POTOMAC HIGHLANDS AIRPORT AUTHORITY  
MINERAL COUNTY, WEST VIRGINIA

RECONSTRUCT AIRPORT ROTATING BEACON

ADDENDUM #1

THRASHER PROJECT #T80-11370

FOOTING DETAILS  
NOT TO SCALE

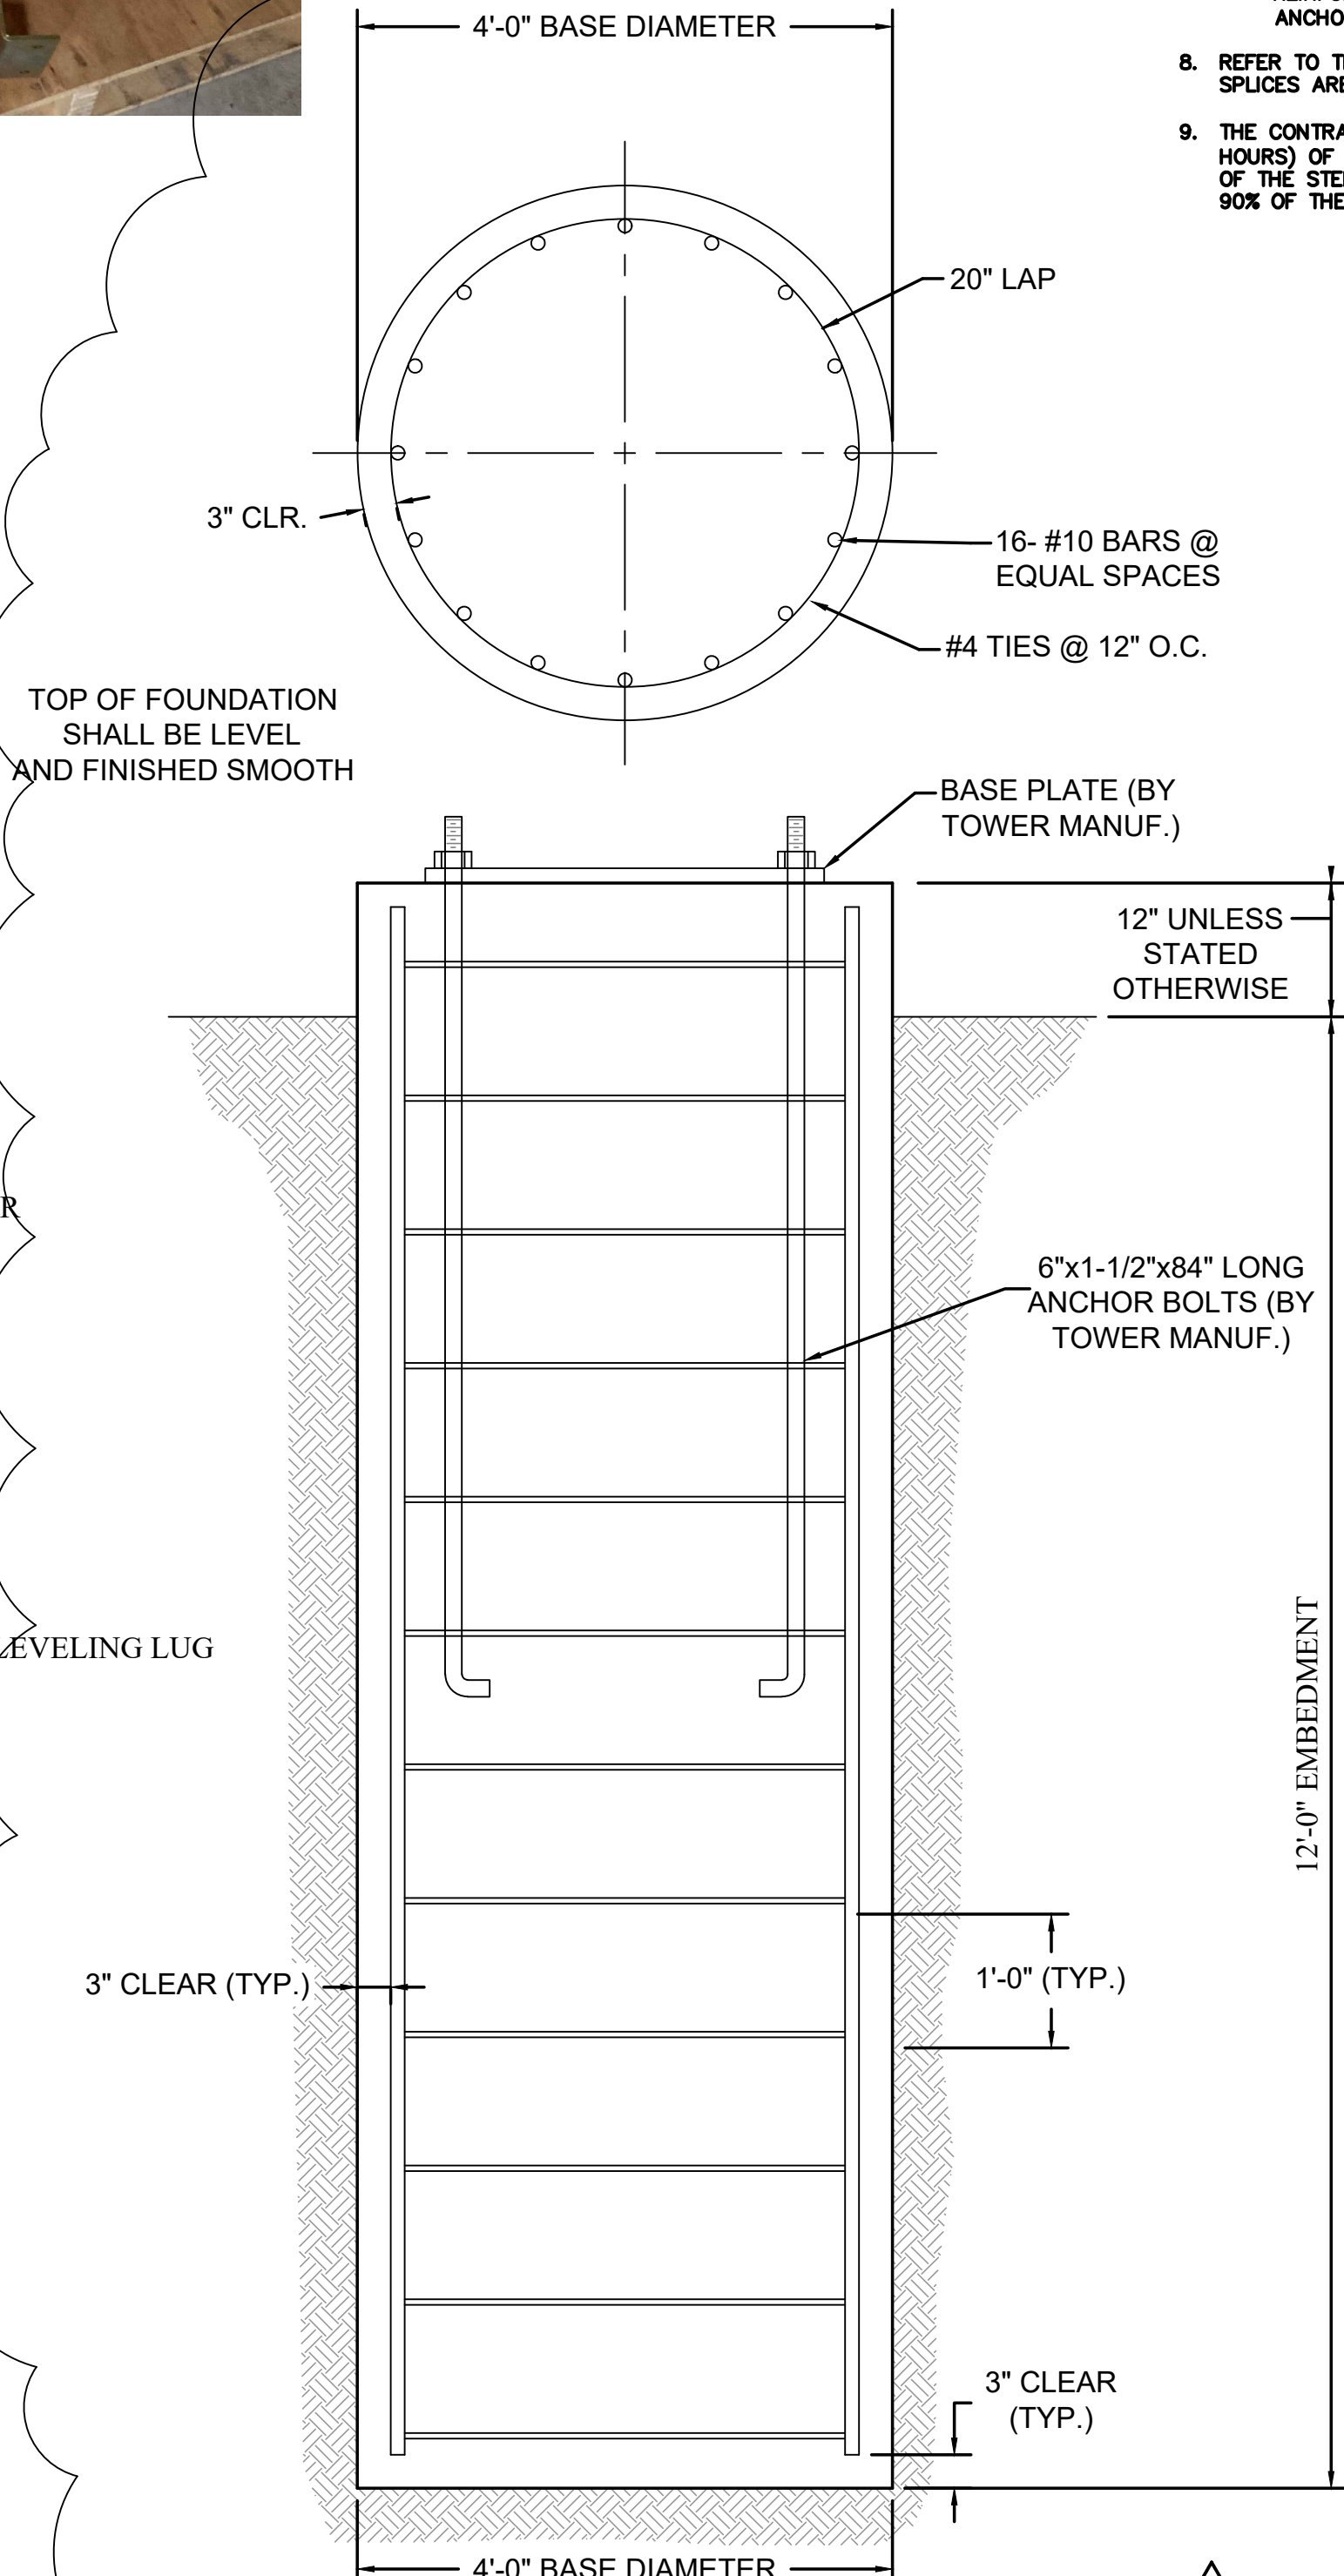
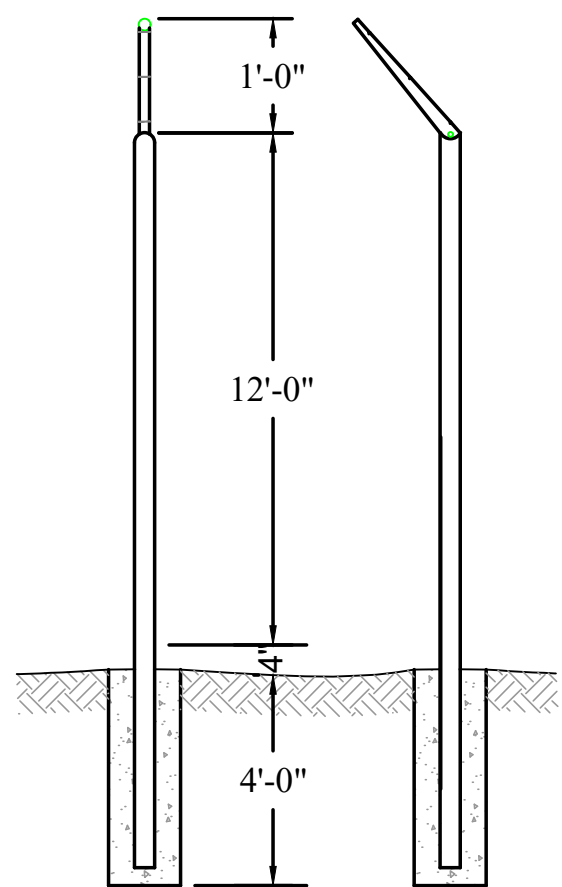
Can you review the detail for the foundation of the beacon tower?

Detail has been modified and a new plan sheet has been attached to this addendum.
